GOVERNMENT OF MADRAS.
REVENUE DEPARTMENT.

READ—the following letter from Major O. V. BODDY, R.E., Acting Deputy Chief Engineer, Public Works Department, to the Chief Engineer, Public Works Department, dated Ennore, 5th June 1890 :—

REPORT.

Ennore salt platforms.

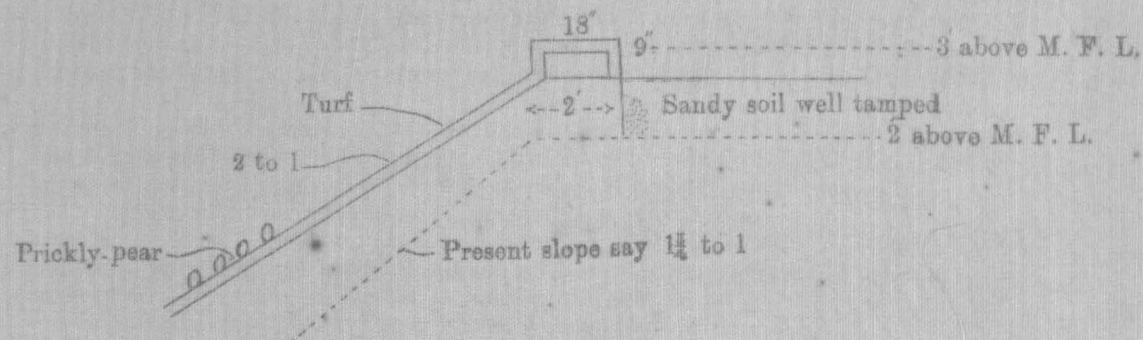
With regard to (d), this arrangement would have been satisfactory, but at several platforms at places this berm has been reduced to 4 or 5 feet. I consider it would have been better to have adhered to a 10' berm as a minimum.

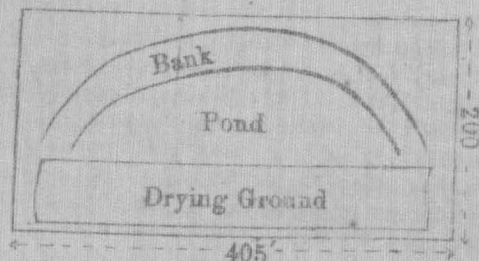
- (a) KATTUR FACTORY.—Platform A.—The soil has a considerable proportion of clay in parts where it has cracked. The slopes are 2 to 1 and are turfed and planted with prickly-pear. There is a good berm from 12' to 20' wide. The surface has been brought up so that, after consolidation, it shall be 2 1/2' above M.F.L. It is recommended to treat it as above described, allowance being made that this platform has only to be raised 6". If emergently required, the present surface may be watered and tamped and used without further raising; but the unoccupied portion of surface must be turfed. This platform measures 875' x 180' and is intended for the storage of 3,01,200 maunds.

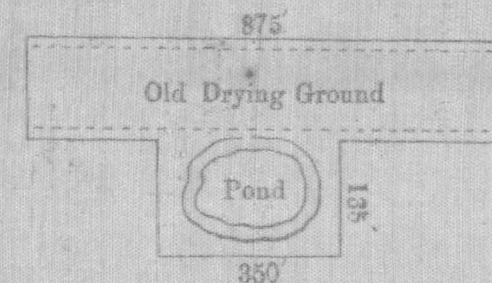
The top level of the platform has been brought up to 3' above M.F.L. The soil is a sandy clay. The surface should be watered and tamped and turf applied as recommended. It can then be used, the proviso as to the 15' space to be allowed not being forgotten. This proviso applies to all the platforms.

Platform B measures 578' x 180' and is intended for the storage of 1,50,000 maunds. The original ground level is similar to that of platform A, viz., drying ground, pond and bank. It has been raised in a similar manner and may be used for storage after treating in the manner indicated for platform A.
